Project Name | BCWD Permit 23-01 CSAH 61 Improvements

Date | March 2, 2023

Regarding | Permit Application No. 23-01 Engineer's Report

Figure 1: Site Plan

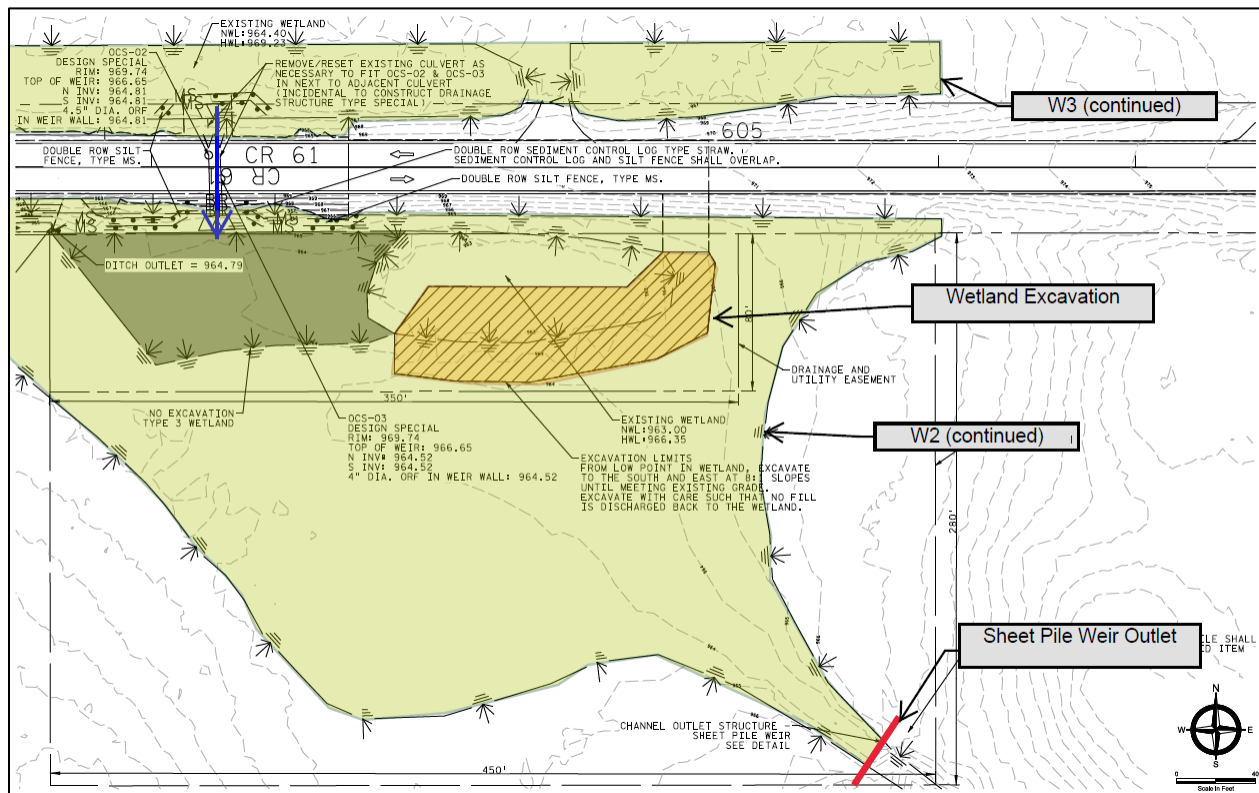
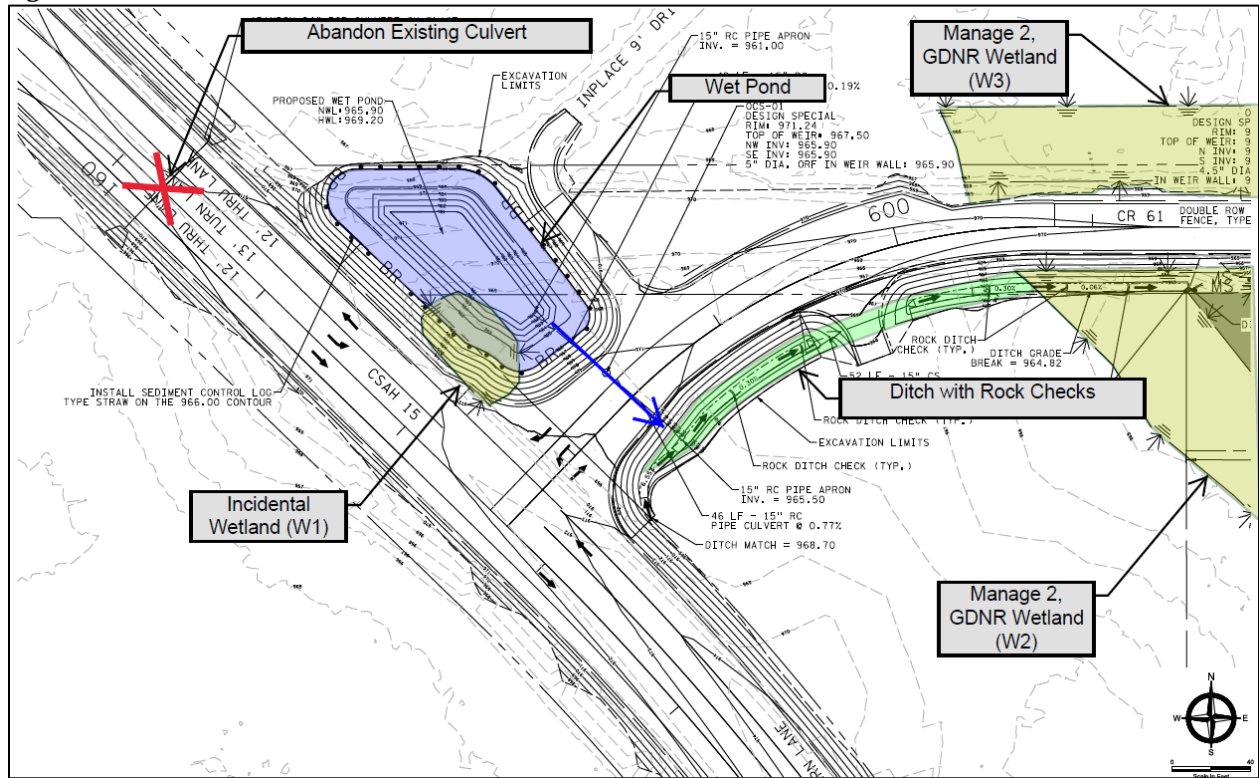
County State Aid Highway (CSAH) 61 currently intersects CSAH 15 (Manning Avenue) at a 45-degree angle and, as indicated by Washington County, does not meet current, applicable design standards for intersection safety. (Please see figure 1, below.) Both roads are rural section with ditches to convey runoff. Runoff from CSAH 15, north of CSAH 61, drains through an east-to-west culvert at the intersection and flows through the neighboring farm field before discharging to Brown's Creek. Runoff along CSAH 61 drains to two wetlands on either side of the highway which are groundwater-dependent, Manage 2 wetlands. The wetland on the north side of the highway (W3) is connected by two culverts to the wetland on the south side of the highway (W2) and the two function hydraulically as one unit. Wetland W2 overflows to the south, through several other wetlands, eventually draining to Brown's Creek.

Washington County proposes to realign the intersection so that CSAH 61 makes a 90-degree angle with CSAH 15, resulting in an increase of 0.25 acres of impervious surface. This project also includes pavement rehabilitation (mill and overlay) along a larger stretch of CSAH 15. New and reconstructed impervious from the road realignment (0.66 acres) will be treated by a wet pond, plus rock check dams along the CSAH 61 ditch to promote infiltration. This ditch drains to wetland W2, which will be partially excavated to create additional open water habitat and improve the quality of the wetland. A sheet-pile weir will be installed at the wetland outlet to provide additional stormwater capacity. The project also includes redirecting runoff along CSAH 15 to drain to the wet pond instead of to Brown's Creek. This addresses a longstanding drainage issue (erosive runoff from the culvert outfall) that has
